Subject: AM RADIO - POOR RECEPTION	Bulletin No: 09-010/07
	Last Issued: 3/21/2007

2006-2007 MX-5 vehicles with VINs lower than JM1 NC**** ** 130963 (produced before November 8, 2006)

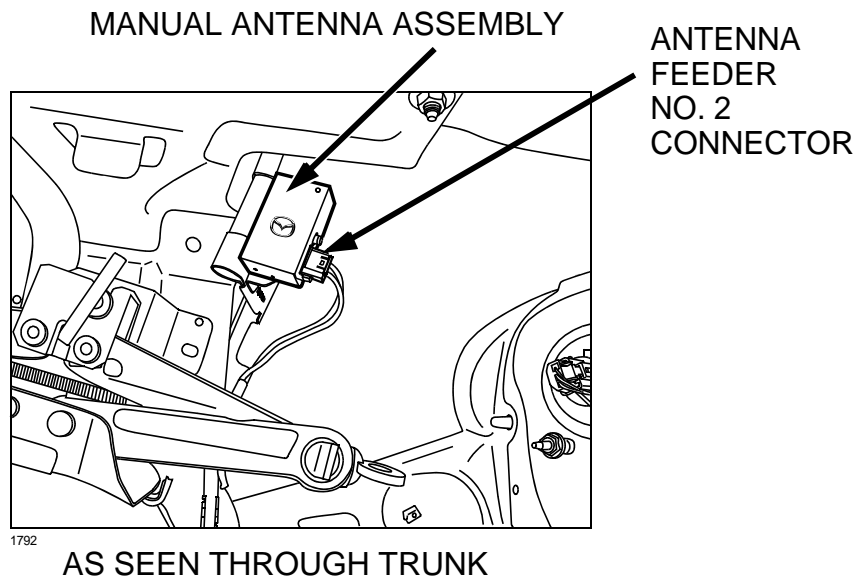
Some vehicles may experience poor reception or excessive static when listening to AM radio stations. This condition may be the result of static electricity damaging the AM amplifier that is located at the base of the antenna.

The antenna amplifier circuitry has been improved to absorb static electricity. Customers having this concern should have their vehicle repaired using the following repair information.

1. Verify customer concern.
2. Replace the manual antenna with a modified one. Refer to Workshop Manual section 09-20 MANUAL ANTENNA REMOVAL / INSTALLATION.
